# Technical Service Bulletin

## 74 Seat pneumatics system activates without driver input

74 13 15 2035757/1 November 15, 2013.

**Figure 2.** Example of DTC set for the control module after SVM code is performed.

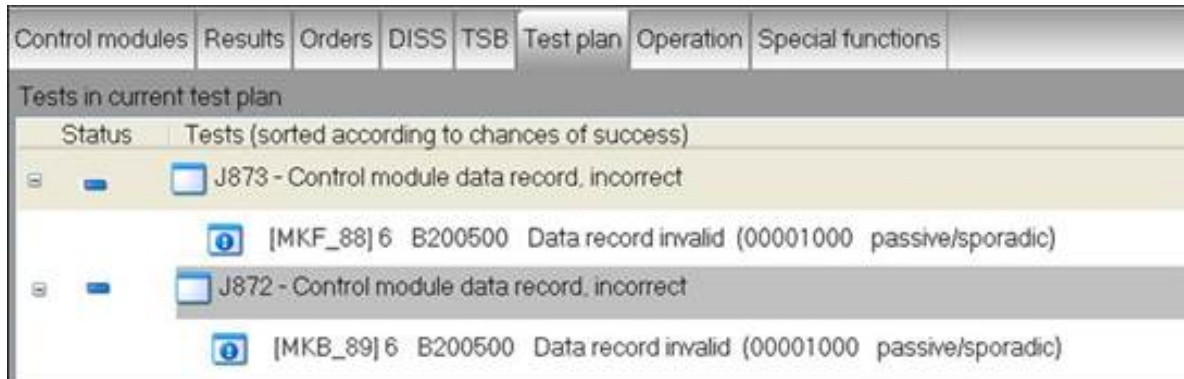
- After the SVM code is performed, one DTC will be set for each control module (Figure 2). Clear the DTCs before finalizing the procedure.
